Delegated Report

Householder Planning Application

Planning Application No: 20230300

Description: Erection of a two storey side extension.

Diagram A & B: Perpendicular Parking

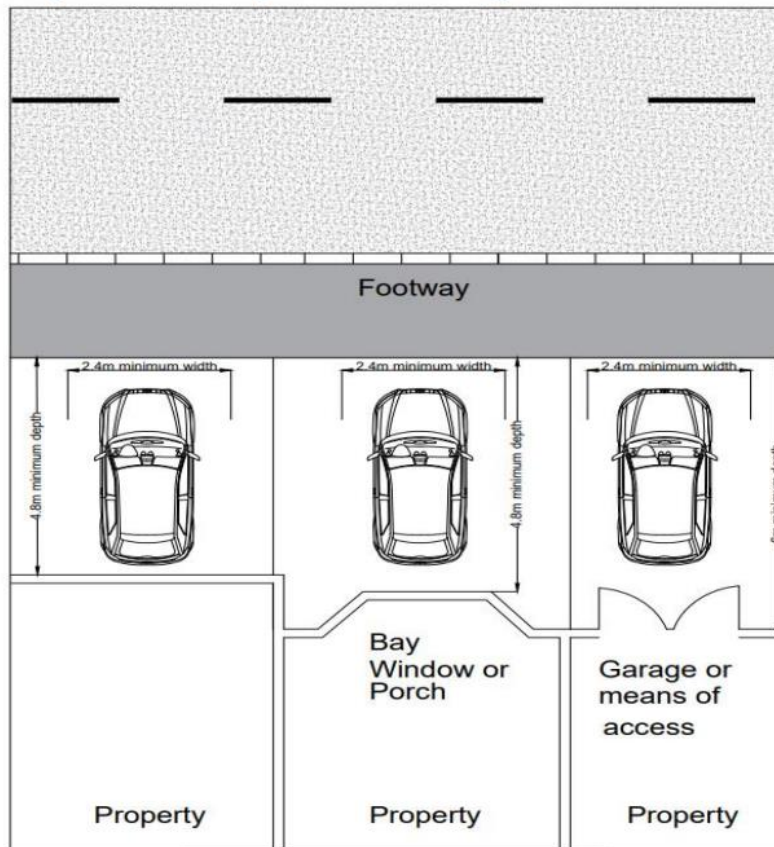
With regards to the actual proposal, currently vehicles should be using the garage and the driveway immediately in front for parking. Vehicles should not be parking in front of the front door, as additional depth is required to ensure pedestrian access exists. The Kent County Council Guidance states 6 metres should exist between the highway boundary and the door to ensure there is suitable access and egress.

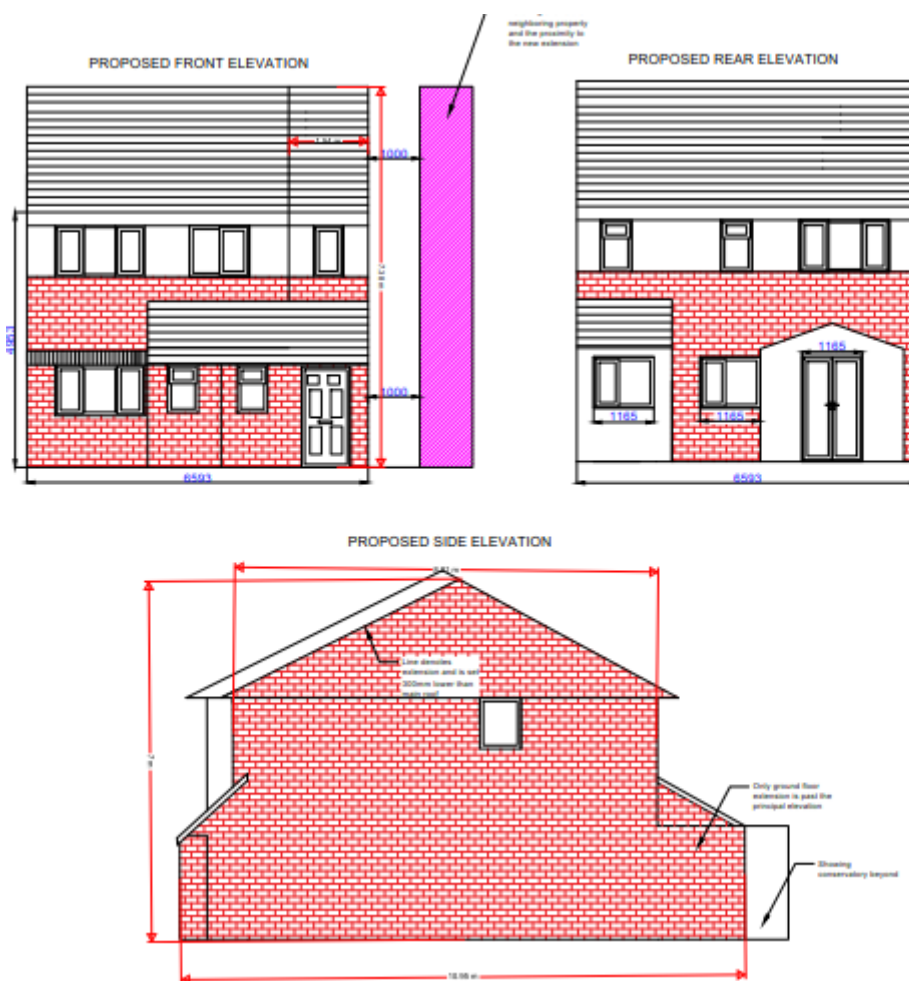
- The new proposed distance between both properties (100cm)
- The proposed side elevation shows the window at a height directly adjacent to a neighbouring window.
- Privacy and noise will be an issue.

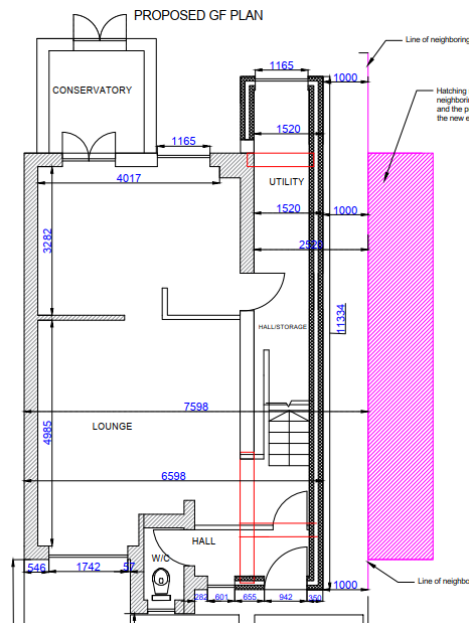
The proposed front and rear elevations show the two storey side extension as being built in line with the main ridge of the house, however the proposed flank elevation shows this as being set down. Should permission be forthcoming the drawings will need to be corrected.

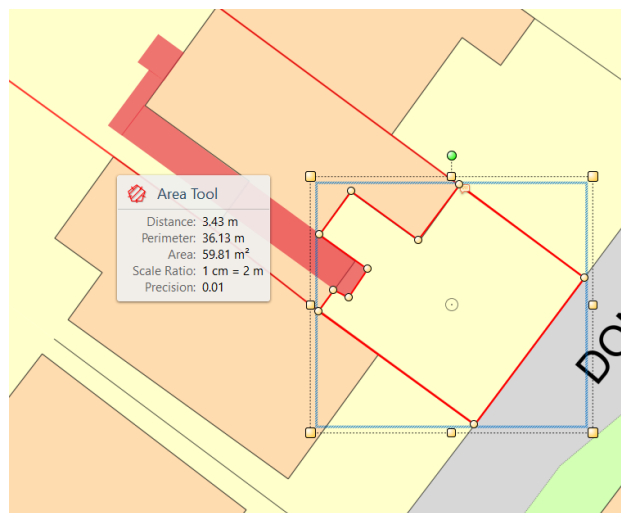
The current proposal has removed the rear dormer which was proposed in the previous submission, however it is considered that a two storey side extension in this locality would not respect the surrounding built form. As can be seen from the below aerial image, there are clear gaps between properties which makes the semi detached and detached nature of the properties in the street clear. A reduction to this gap would not respect the wider building pattern, and make the dwelling appear cramped and 'squeezed in' on the plot.

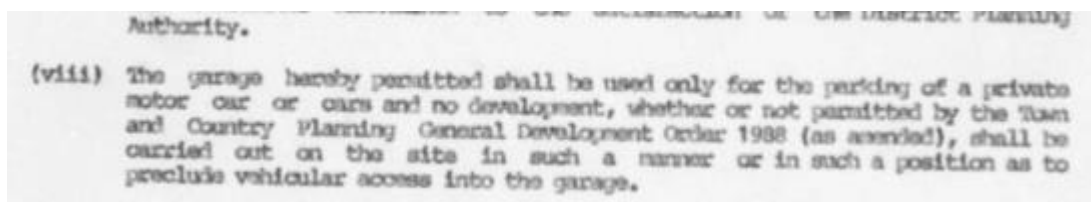
The proposal is not liable to impact light outlook or privacy to the adjoining property known as No.43 Haig Gardens as the two storey extension is situated to the southern side of the property. However, should permission be forthcoming a condition would be imposed to ensure any window serving a bathroom is retained as obscure glazed and top hung.
